GROUP	MODEL
BOD	2023MY Niro EV/HEV/PHEV (SG2 EV, P/HEV)
NUMBER	DATE
310 (Rev 1, 11/18/2022)	October 2022

TECHNICAL SERVICE BULLETIN

SUBJECT: **SERVICE ACTION: FRONT CARPET FLOOR MAT ANCHOR INSPECTION AND REPLACEMENT (SA509)**

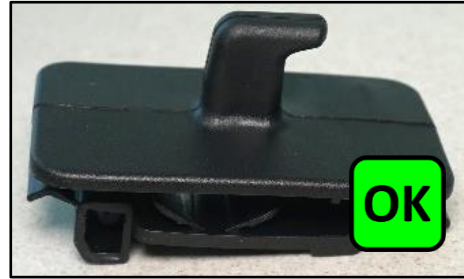
NG: Ring Type Anchor
(non-U.S. specification)

OK: Hook Type Anchor
(U.S. specification)

- Inspect the front carpet floor mat anchors on both the driver (LH) and passenger (RH) sides.
 - If the floor mat anchor installed is the 'hook type' (OK), no further action is required.
 - If the floor mat anchor installed is the 'ring type' (NG), then proceed below to the 'Replacement Procedure' to replace all three (3) front floor mat anchors with the correct type.

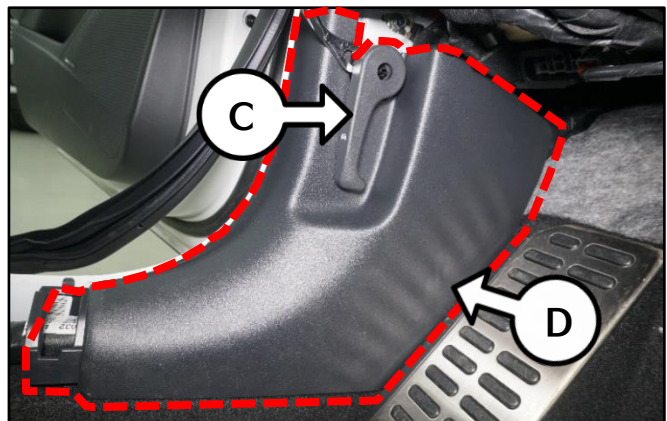
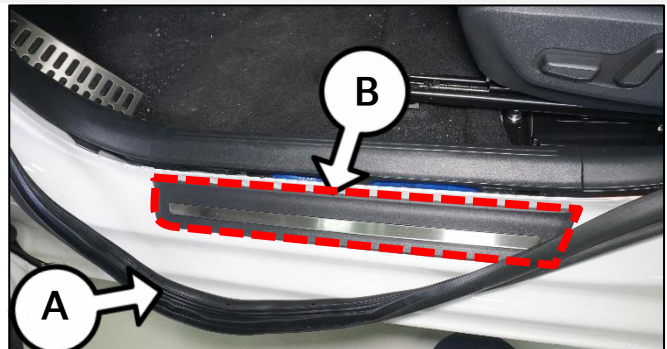
- Remove the components listed below by referring to "Body (Interior and Exterior) → Interior Trim → Cowl Side Trim → Repair procedures" in the applicable Shop Manual on KGIS to access both left and right sides, floor mat anchors.
 - Front door weatherstrips (A)
 - Front door scuff trims (B)
 - Hood latch release handle (C)
 - Cowl side trims (D)

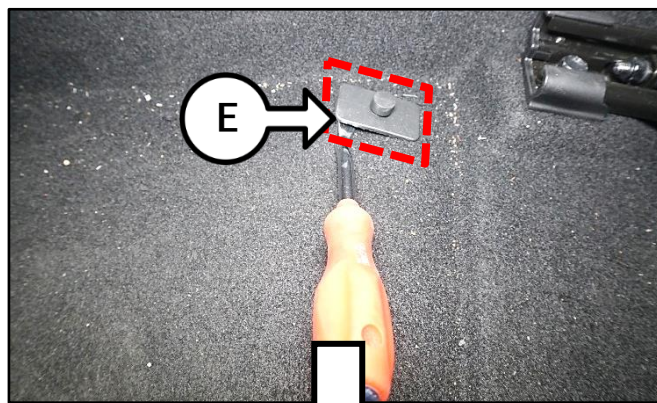
2a. Using a trim removal tool, unlock the anchor (E) from below to detach it from the base (F) located underneath the floor carpet.

2b. Remove the anchor (E).

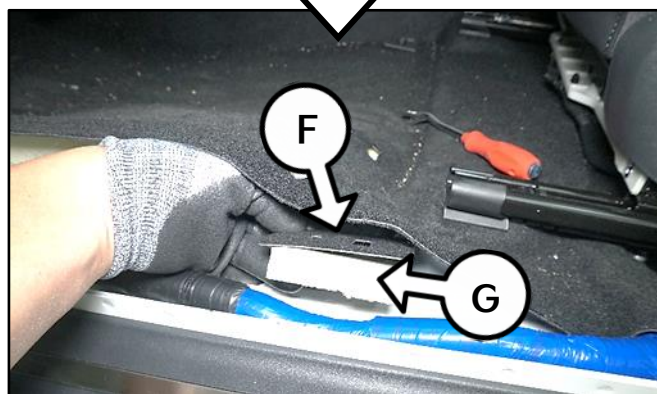
3. Remove the loose anchor base (F) and anchor pad(s) (G) from underneath the carpet.

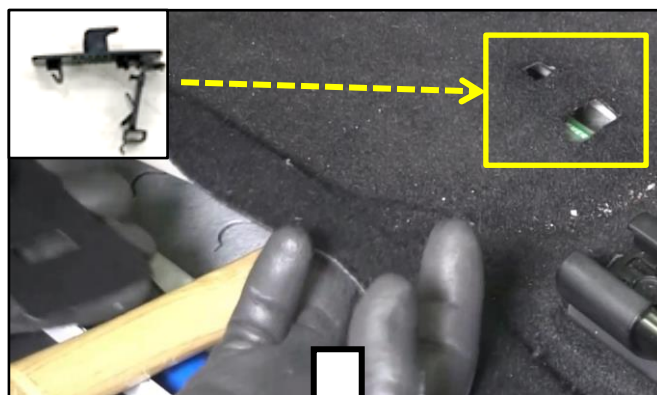
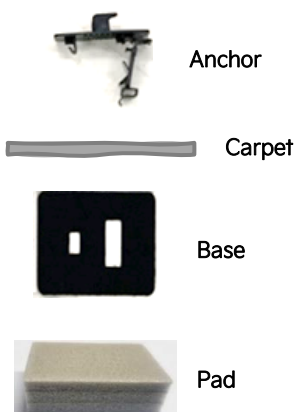
4. Install the (3) new anchors:

- Two (2) driver (LH) side
- One (1) passenger (RH) side

Note: Hooks are pointed towards the rear.

For HEV/PHEV models, be sure to use the correct thickness pads by referencing the table guide below.

*Note: The (35mm) pad, must be used for the left driver side, inboard anchor.
